SUBSURFACE WASTEWATER DISPOSAL SYSTEM APPLICATION

Subject: Approval, First Time System Variance Request, Hutchings property, Off Cony Street Extension, Augusta

FIRST TIME SYSTEM VARIANCE REQUEST

SUBSURFACE WASTEWATER DISPOSAL PLAN

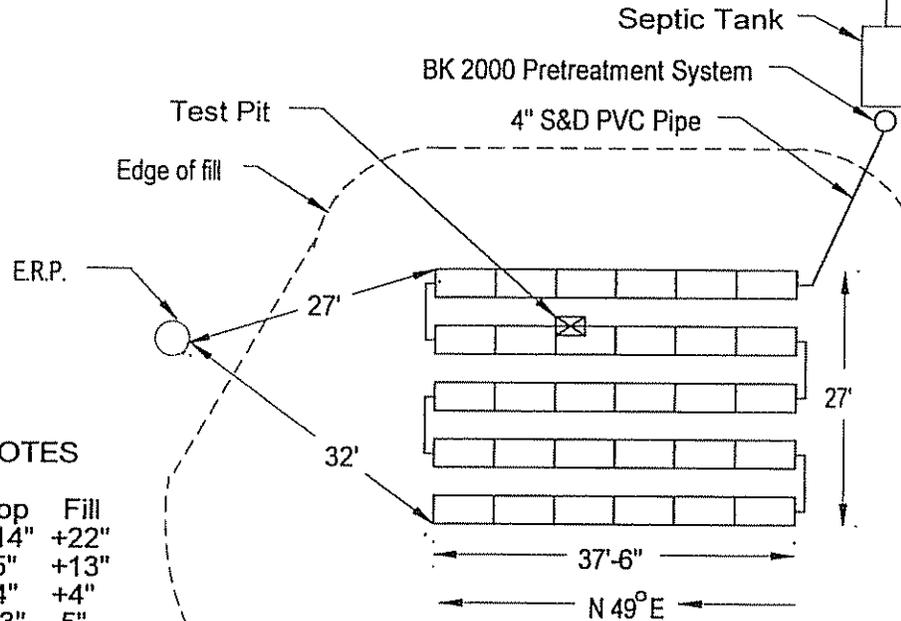
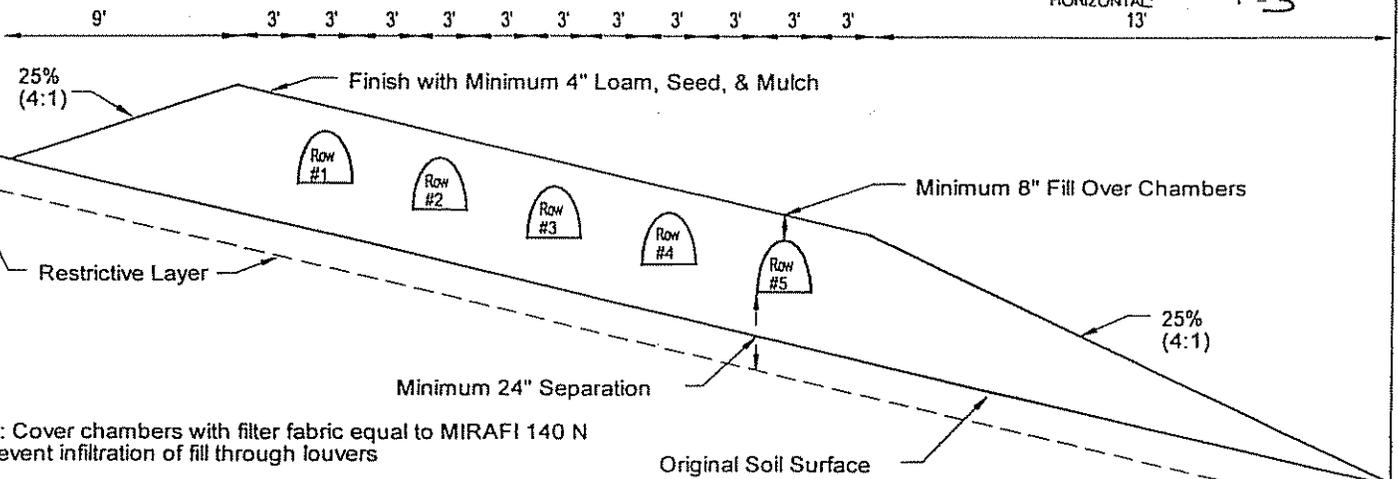
The Division has reviewed a First Time System Variance Request for the subject property. The proposal is to install a subsurface wastewater disposal system to serve a three-bedroom single-family dwelling. The state variance requested is to allow the installation of the system in soils with 10 inches to the ground water table. The system design, prepared by Stephen Robbins, SE, dated February 18, 2002, includes an increase in disposal area, an increase in vertical separation and additional treatment measures to achieve the required First Time System Variance Total Point Assessment. The design is otherwise found to be in compliance with the Maine Subsurface Wastewater Disposal Rules.

We approve the requested variance with the following requirements:

1. A permit for system installation shall be obtained from the Local Plumbing Inspector in advance of the start of system construction.
2. The system shall be installed in accordance with the submitted and approved system design. Should alterations be required at the time of system installation, the system designer must be notified prior to making any changes.
3. The variance approval is based only on the rules administered by this department. The approval of the variance request does not relieve the property owner from compliance with all other state and local requirements pertaining to the installation, use, and operation of the wastewater disposal system.
